For Trench/Disturbance Permit within the City of New Bedford

RE: TB-21-83
Farland Circle (N.E.S.) S. x Phillips Rd. (a/k/a Builder's Lot 6)
Plot 130D Lot 475
Reviewed 1/21/2021

- 1.) The site plan submitted in View Permit, titled: "Site Plan, Farland Circle, Assessors Map 130D Lot 475, New Bedford, Massachusetts", having a date of 8/17/2020 (last revised 1/5/2021), as prepared by Farland Corp. and stamped/signed by Christian A. Farland, P.E. (Civil), is approved for obtaining DPI permits, with the following comments:

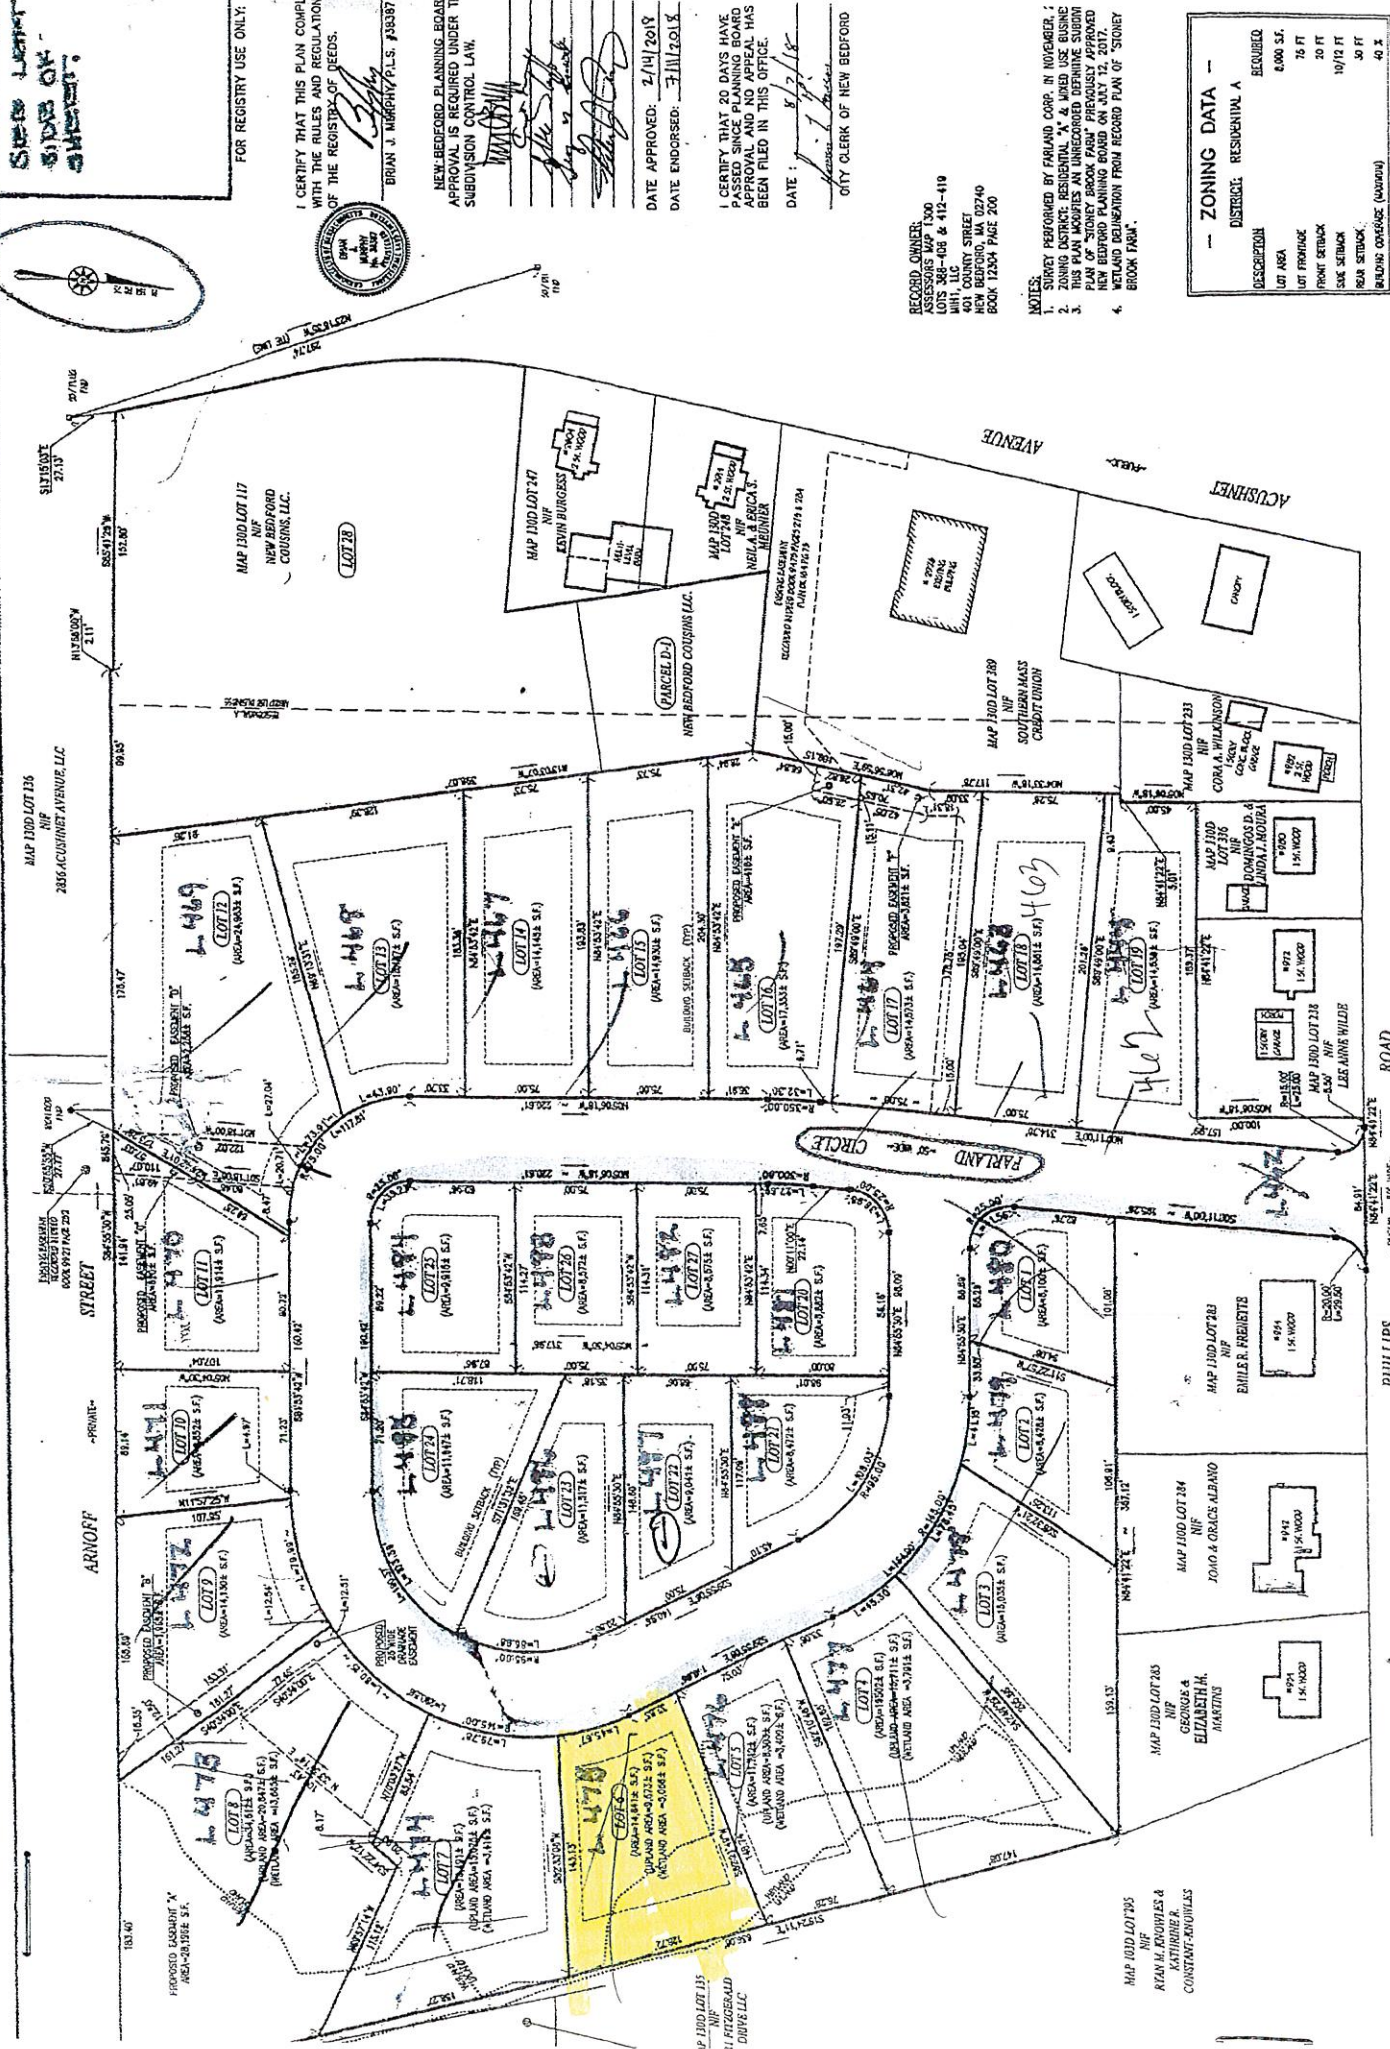
- : 1. Sewer service to be 10 ft away from water service.
- 2. Water service to be perpendicular (90 degrees) from main to property line
- 3. Water curb stop (shut -off) to be 1.5ft from face of curb/pavement.
- 4. Install water meter at point of entry to building
- 5. Owner to apply for water and sewer permits.

: FOUNDATION FOR NEW SINGLE-FAMILY DWELLING
with a 5'x5' front porch with no roof
